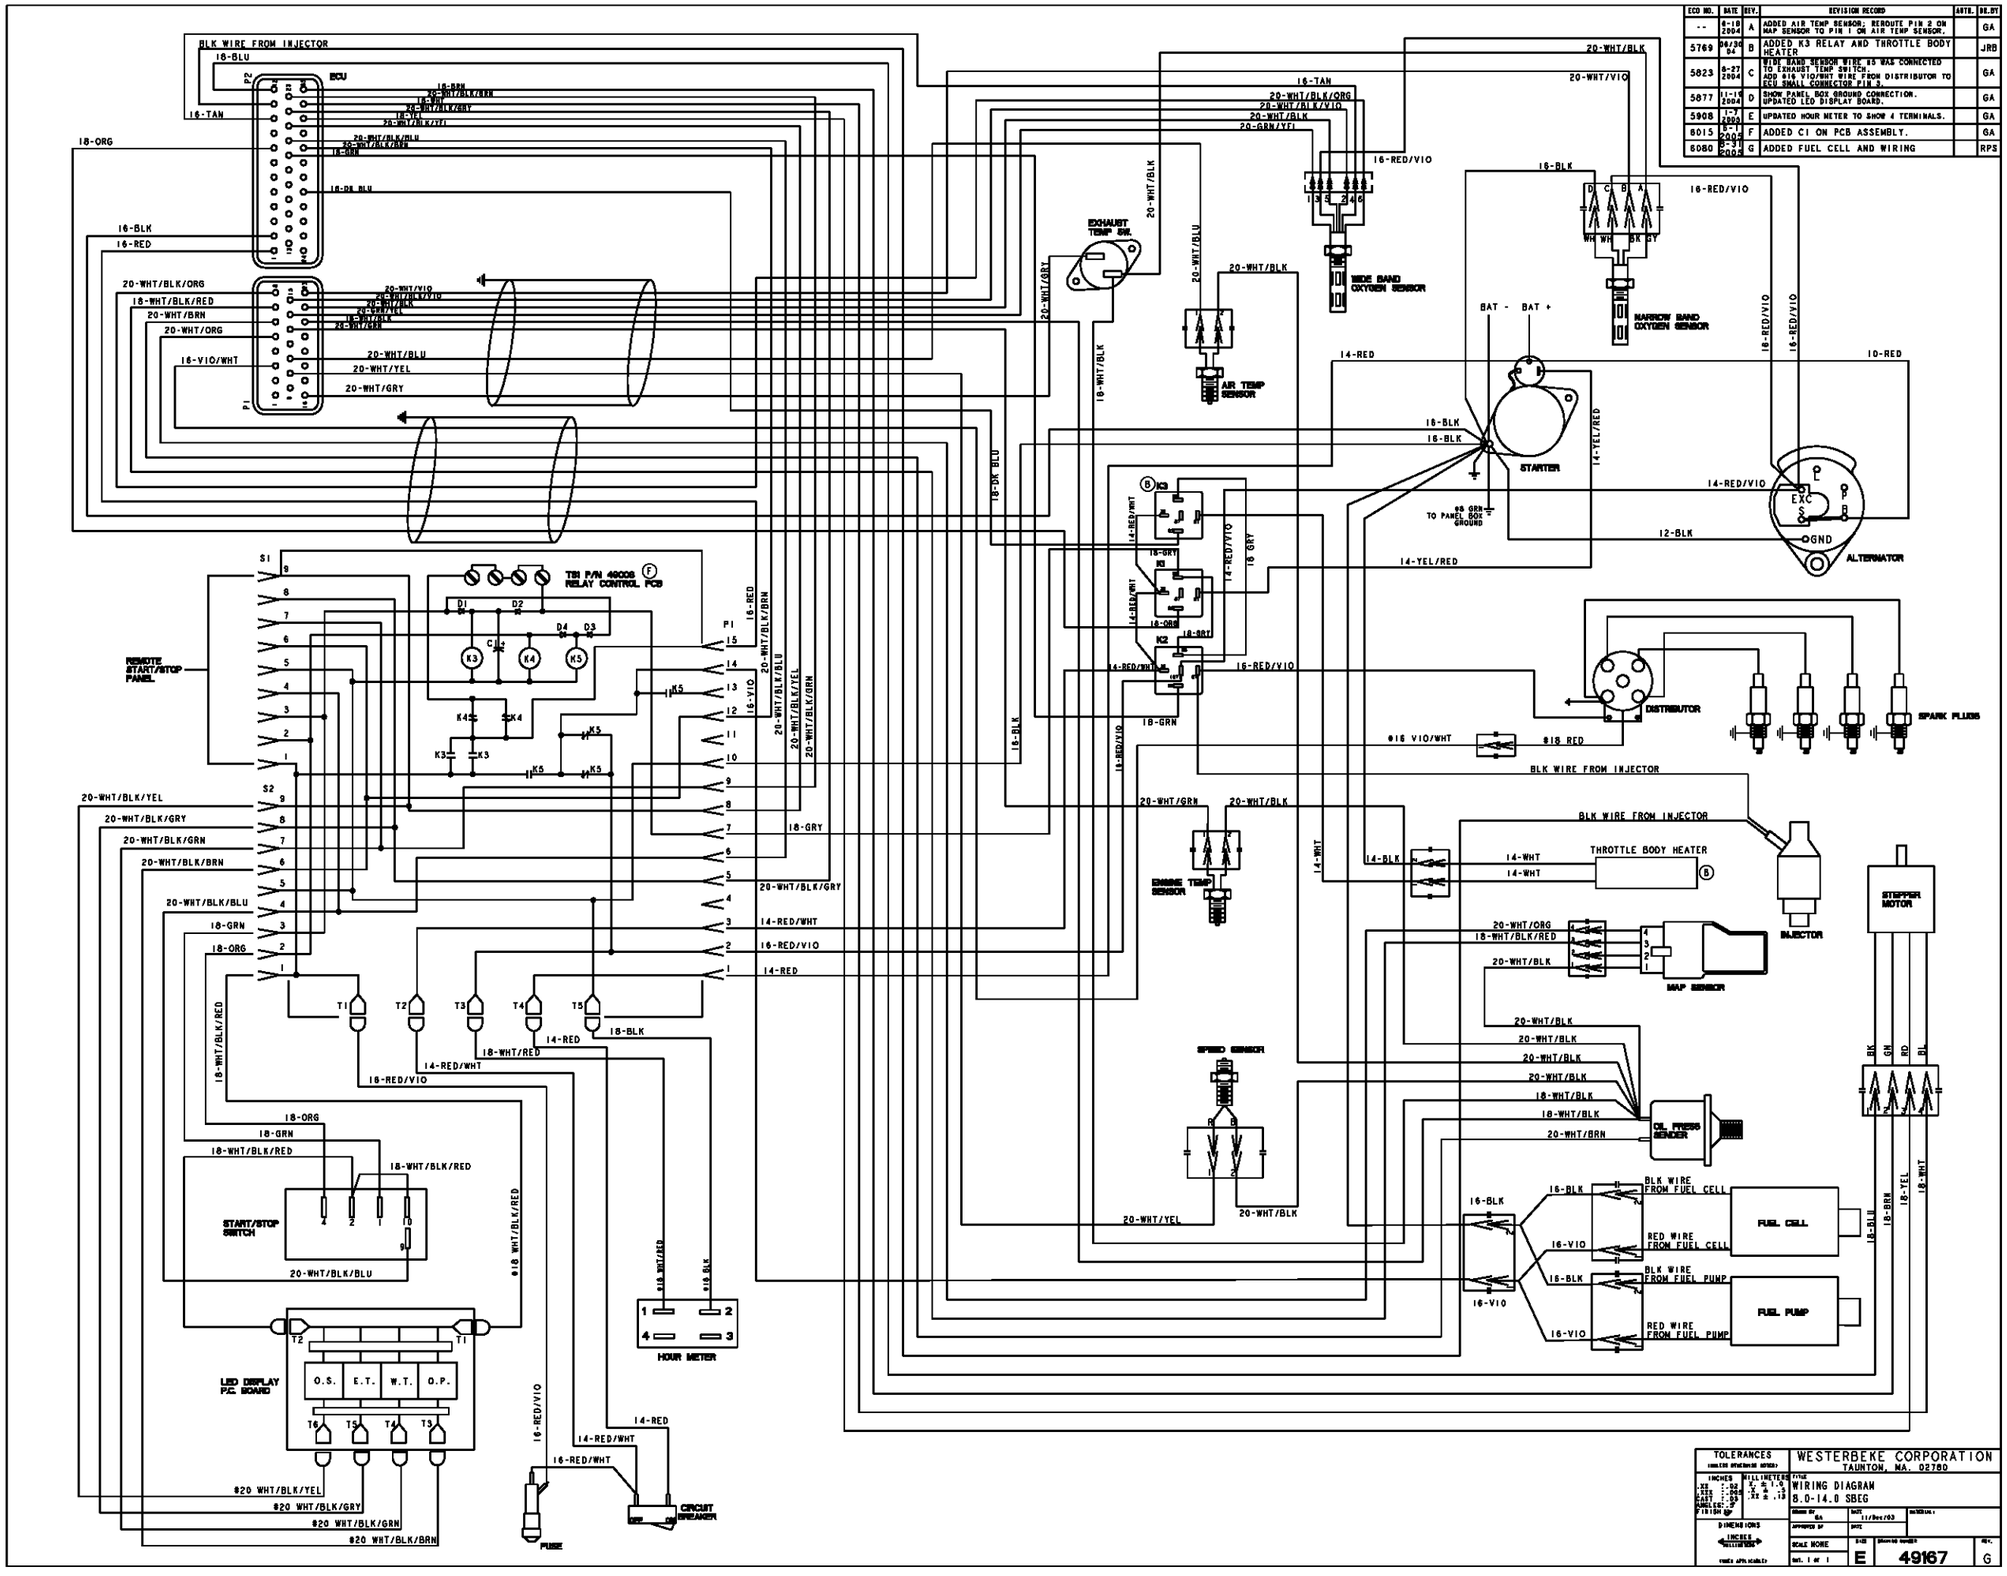
ECO NO.	DATE	REV.	REVISION RECORD	APPR.	DR. BY
--	6-18 2004	A	ADDED AIR TEMP SENSOR; REROUTE PIN 2 ON MAP SENSOR TO PIN 1 ON AIR TEMP SENSOR.		GA
5769	06/30 04	B	ADDED K3 RELAY AND THROTTLE BODY HEATER		JRB
5823	8-27 2004	C	WIDE BAND SENSOR WIRE #5 WAS CONNECTED TO EXHAUST TEMP SWITCH. ADD #18 VIO/WHT WIRE FROM DISTRIBUTOR TO ECU SMALL CONNECTOR PIN 3.		GA
5877	11-19 2004	D	SHOW PANEL BOX GROUND CONNECTION. UPDATED LED DISPLAY BOARD.		GA
5908	1-7 2005	E	UPDATED HOUR METER TO SHOW 4 TERMINALS.		GA
6015	5-11 2005	F	ADDED C1 ON PCB ASSEMBLY.		GA
6080	8-30 2005	G	ADDED FUEL CELL AND WIRING		RPS
